SERVICE BULLETIN

FUJI HEAVY INDUSTRIES LTD.

NO : FAS-043

1. SUBJECT : Improvement of cabin ventilating system.
2. AIRCRAFT AFFECTED : All FA-200 Series Serial Nos. 1 thru 101.
3. PRIORITY : Desirable.
4. REASON : In order to take cool air into canopy by installing air scoop and four air outlet at upper surface of canopy door.
5. DESCRIPTION : Air-outlet at upper surface of canopy door.
6. ACCOMPLISHMENT : Optional.
7. APPROVAL : JCAB Approved.
8. PARTS REQUIRED : The following parts are required to perform the rework:

FIG. 2 AIR SCOOP INSTL (VIEW FROM CABIN INSIDE)
(REFER TO VIEW A-A TOGETHER)

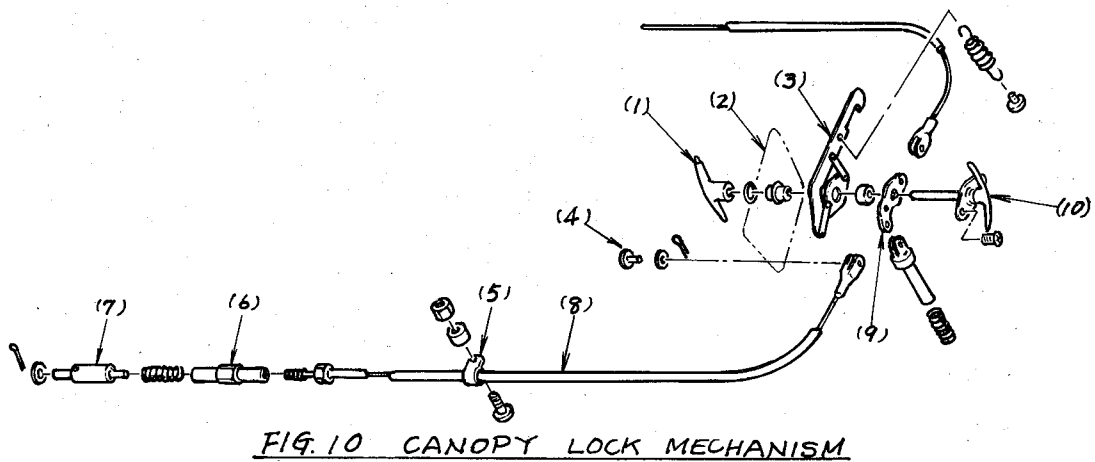
- l. Install the guide, 200-534320-003 and -004, and Scoop Assy, 200-534323-001, for c zone in Fig. 1. For these installation refer to Fig. 2. and Fig. 7.

FIG. 3 OUTER SKIN MODIFICATION
IN AIR SCOOP INSTL

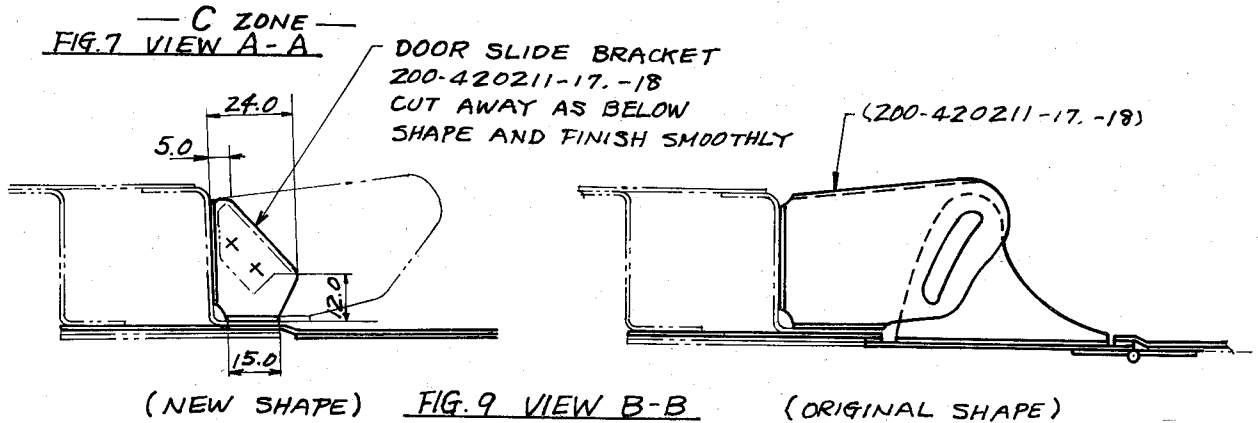
- (d) Cut away door slide bracket, 200-420211-017 and -018, with same manner as shown in Fig. 7.
- k. Cut away outer skin at C zone in Fig. 1. in accordance with the manner as shown in Fig. 3.

REMOVE 200-420005-31-32
REMOVE 15 RIVETS

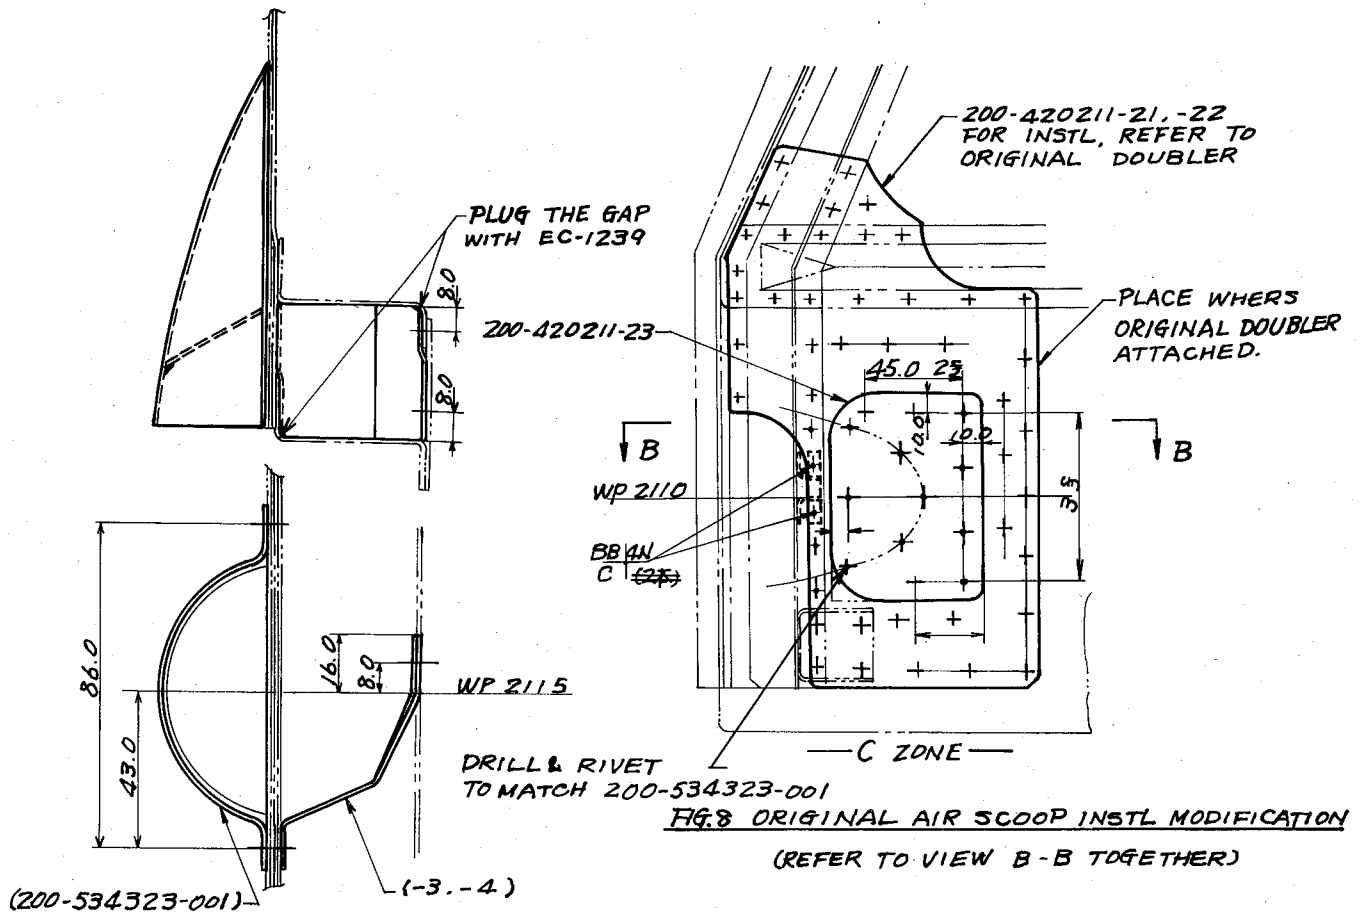
- m. Cut away stiffener in E and F zone in Fig. 1. For the cutting details, refer to Fig. 5. and Fig. 4. Install the doubler, 200-420005-063 and -064 at opening place as shown in Fig. 4. Remove the doubler, 200-420005-031 and -032 with fifteen rivets.

FIG. 12 CUTTING DETAIL (4 PLC'S) FOR BRACKET

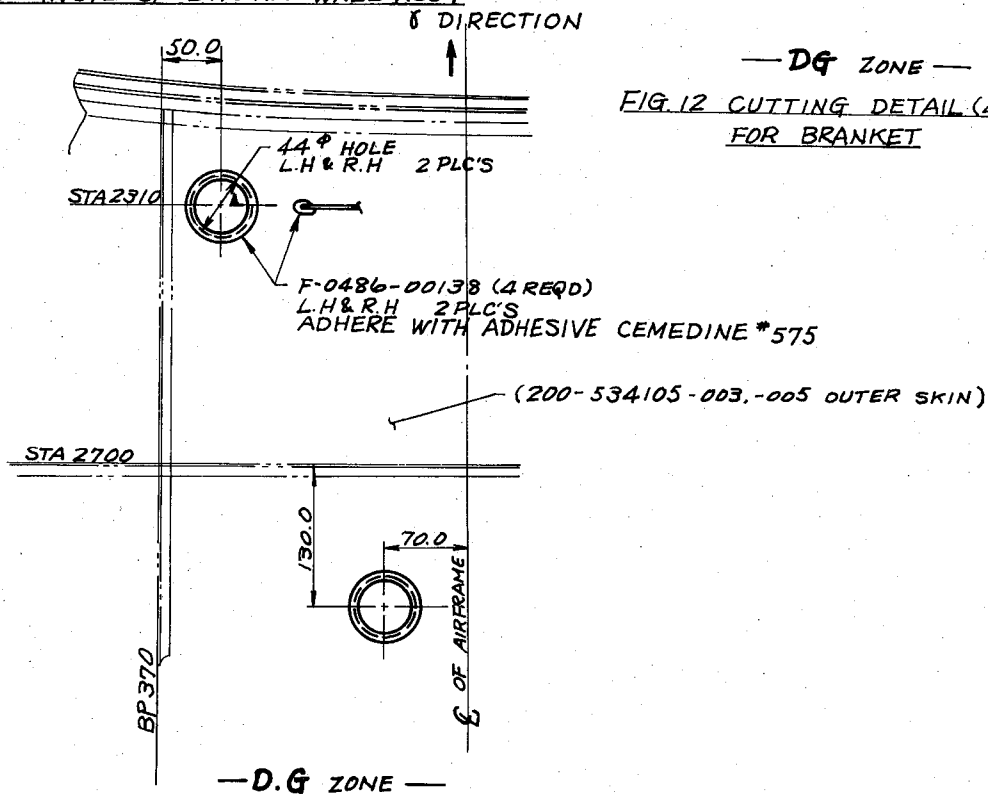
- r. Install frame outer skin removed in step 8.
- s. Cut away new branket, 200-534102-053, -055 and -057 as shown in Fig. 12 and adhere with adhesive cemedine #540.
